GLOBE STAR-A Schematic Diagram

FR-056-L (revised 7-64)

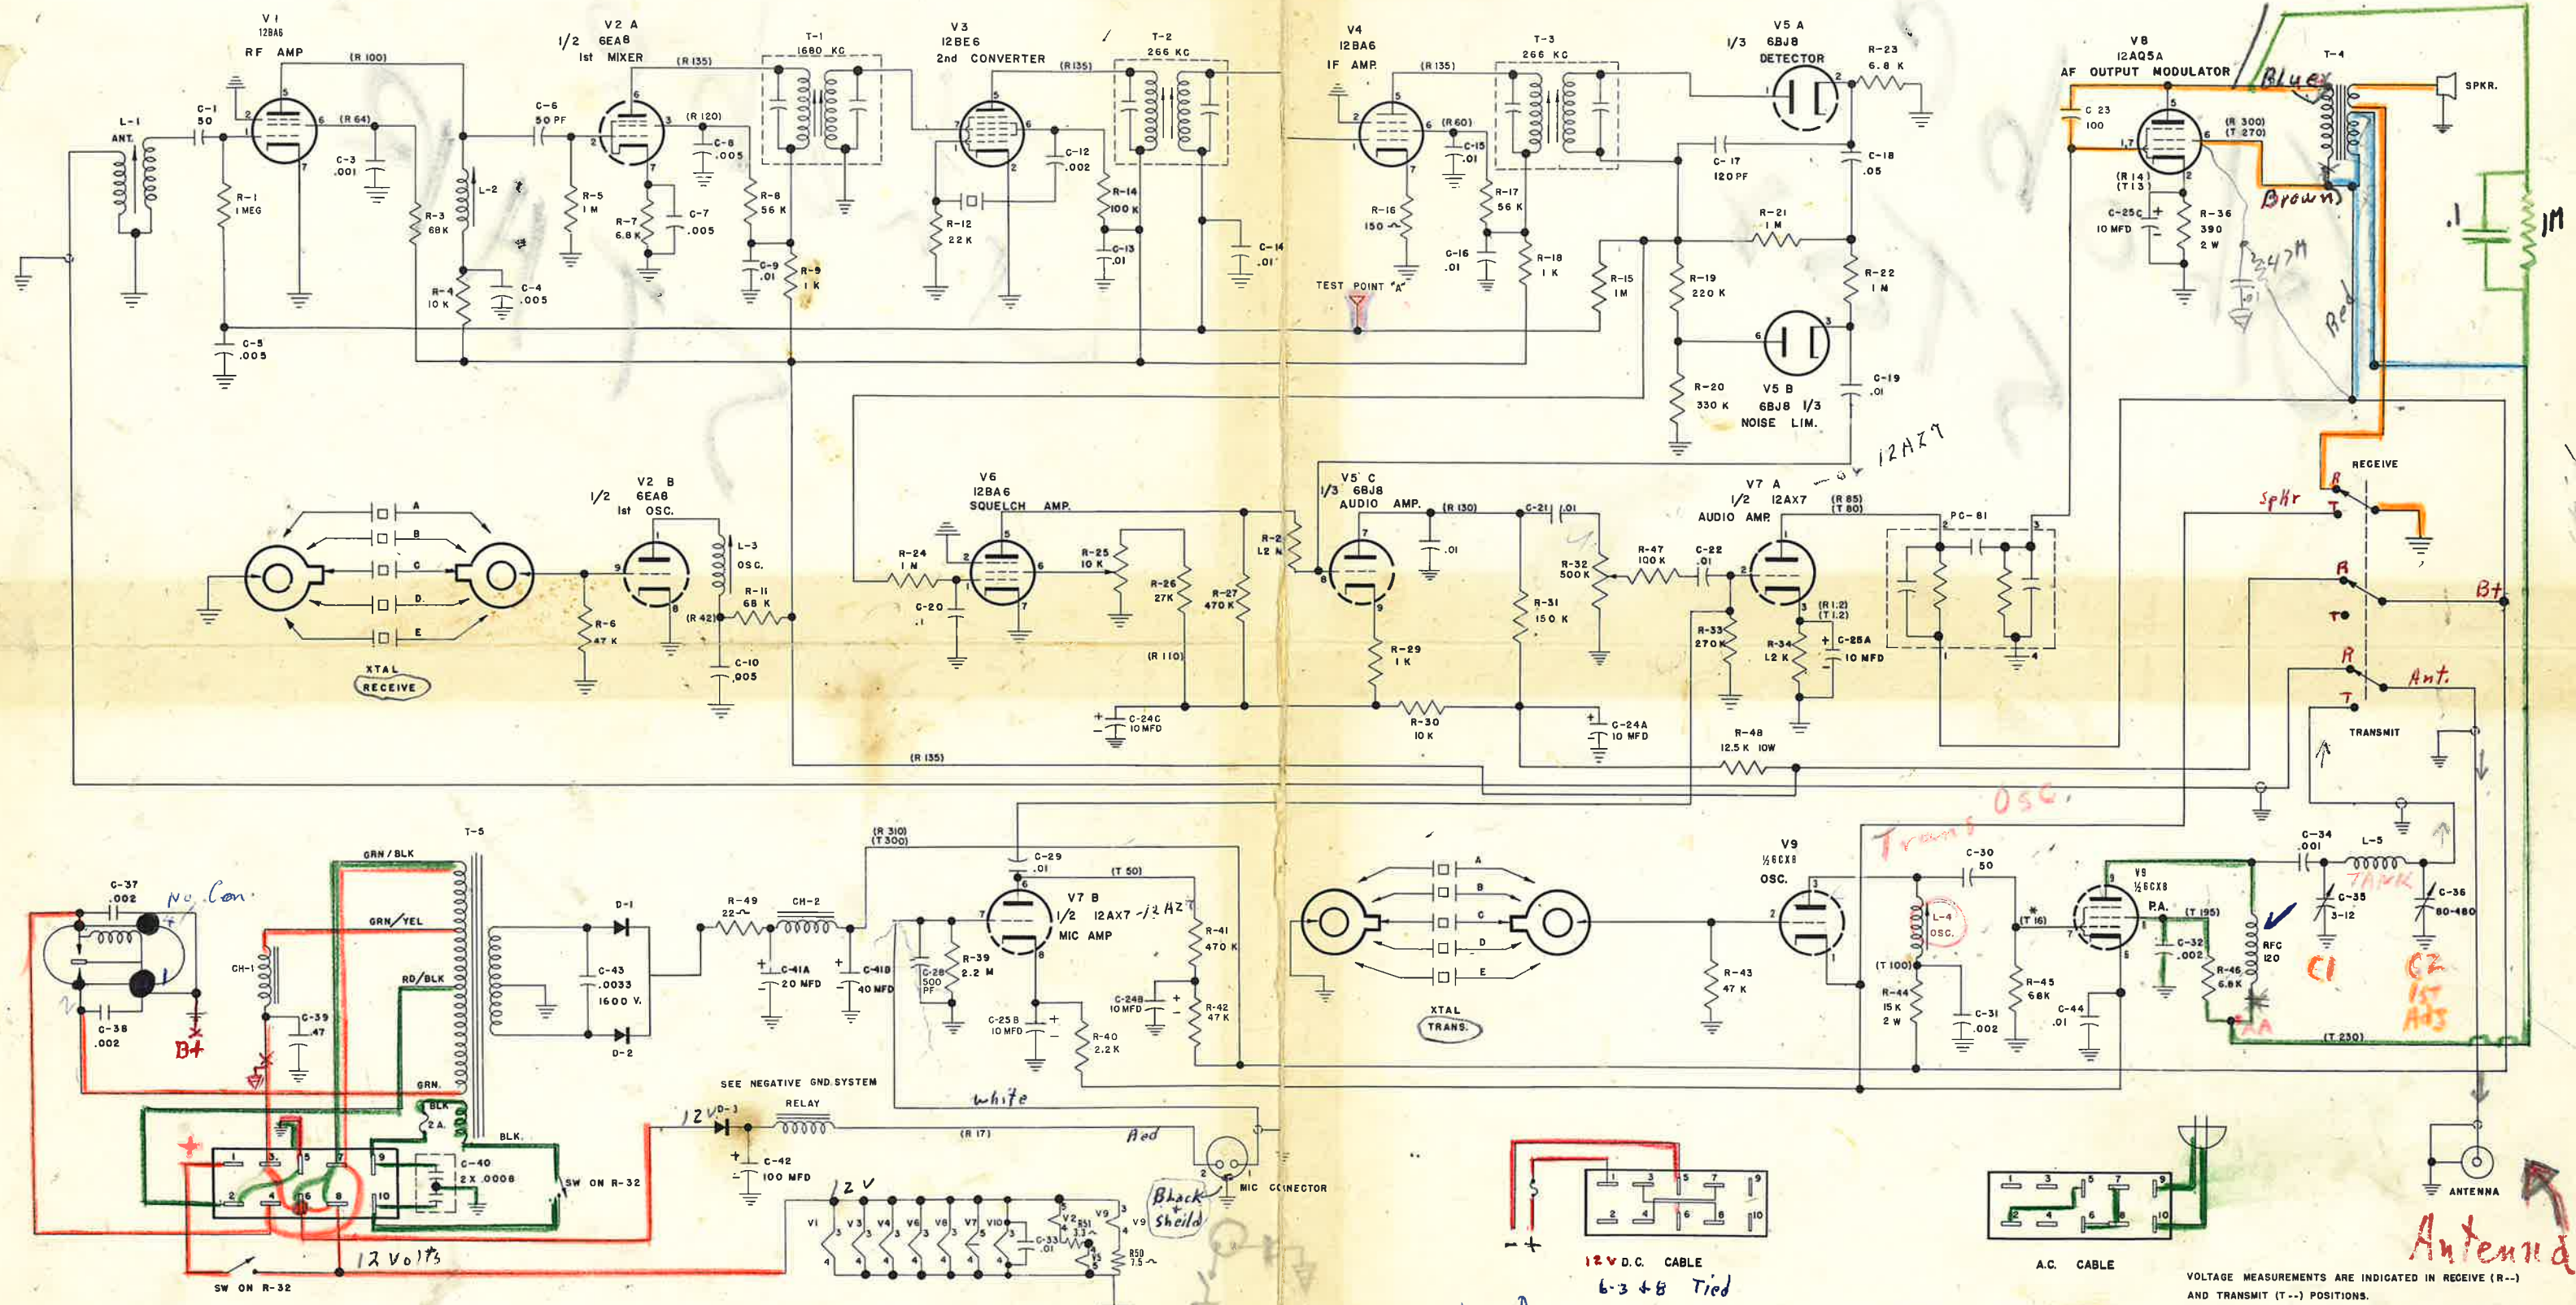
Does Not Exist on Globe Star
 - Exist on Globe Star + on CB-200 Diagram

Reverse point X (2) for Transistor Vibrator (Remove Vibrator for Use on AC)
 Pin 1 must be B+ for Transistor Vibrator
 Choke added Between Pin 1 & Positive

1000 ohm across a Cond (Tubular)
